APPLICATION FOR AMENDMENT TO  
OPERATING LICENSE

Indian Point Unit 3  
Docket No. 50-286

August 26, 1976

Safety Evaluation

Figure 6.2-2 Facility Organization

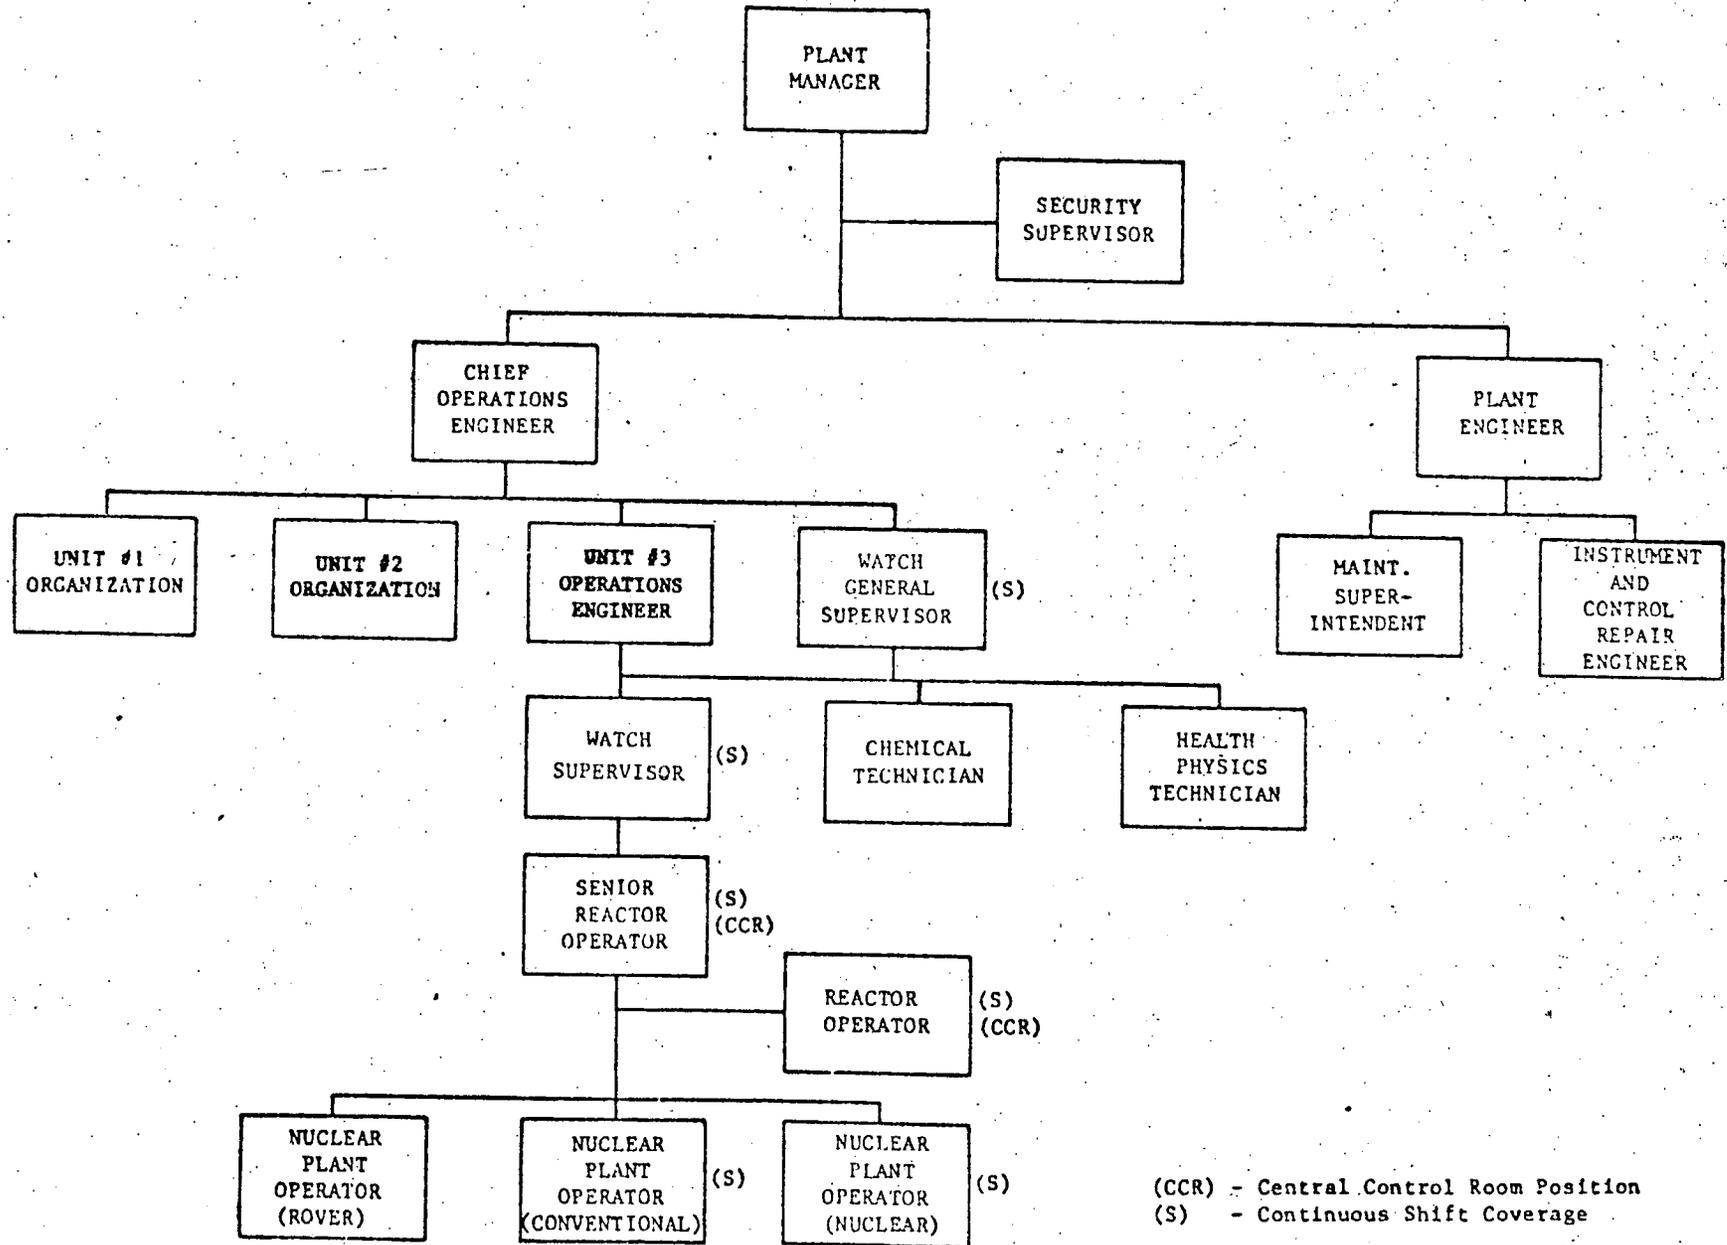
The proposed revisions to Figure 6.2-2 would reflect pending changes in employee titles. These revisions would only represent title changes and would not alter the responsibilities or functions of the personnel involved.
